TECHNICAL BULLETIN	
	July 2003 TB 2087
Mfg:	NISSAN
Model:	PATHFINDER
Liter:	3.3L
V I N:	T
Year:	96-06

Engine Coolant Leaks On
2000-02 Nissan 3.3 VG33E Engines

Bulletin Diagram: NEW GASKET - MANIFOLDS

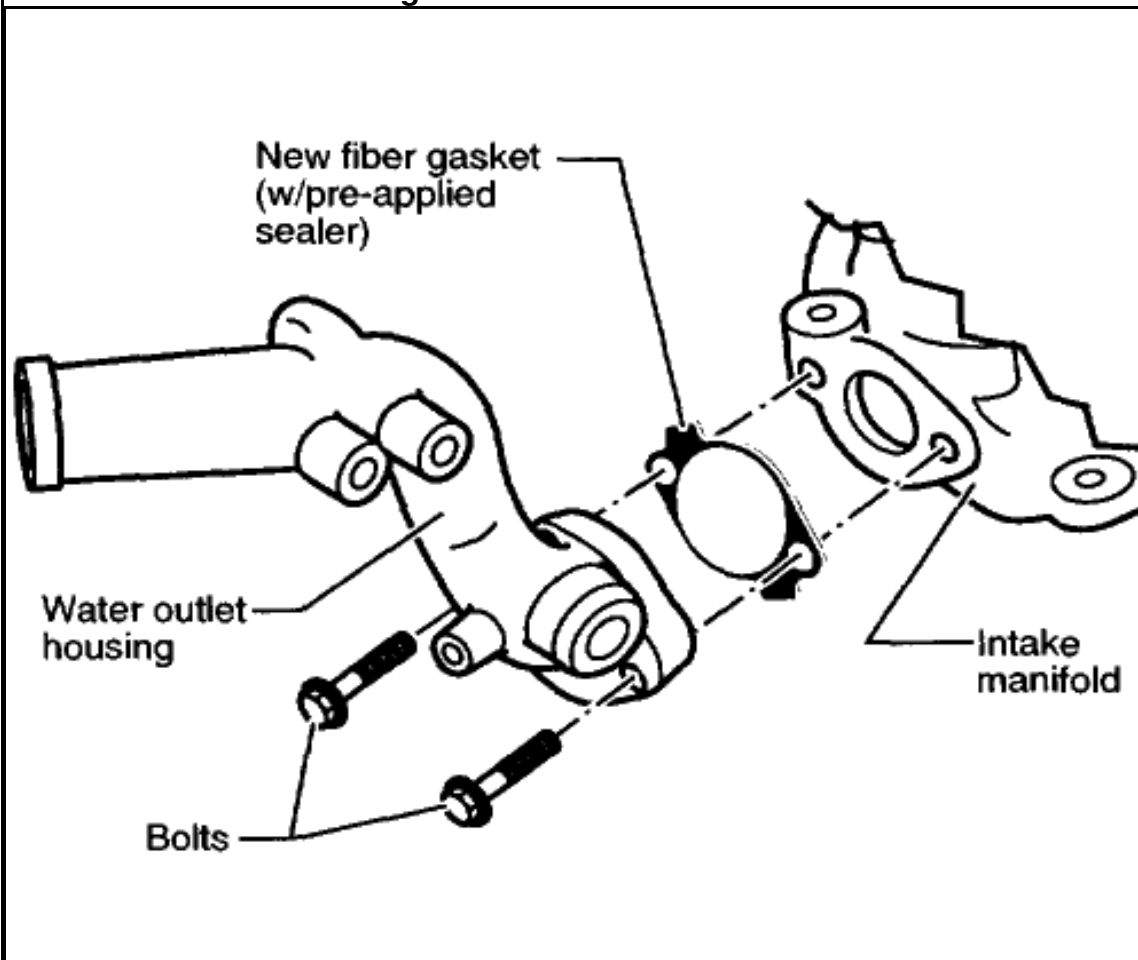
A leak between the intake manifold and the water outlet housing as shown below in Figure 1 may be causing this condition. Visually inspecting this area could verify that this is the source of the leak.

To cure this problem, Nissan offers a revised fiber gasket, Part #11062-9Z000, to be installed between the water outlet and the intake manifold. When changing this gasket, make sure that you have drained the coolant just below the level of the water outlet. This will keep coolant from spilling when removing the housing.

Clean the sealing surface of the water outlet housing and the intake manifold to get rid of any old sealer that may be present. Install the two mounting bolts through the outlet housing and then slide the fiber gasket over the bolts until it is flush with the sealing surface of the housing.

Once the housing is installed onto the intake manifold, tighten the mounting bolts to a torque of 12-15 ft/lbs. Refill the cooling system and run the vehicle to verify that there are no further coolant leaks.
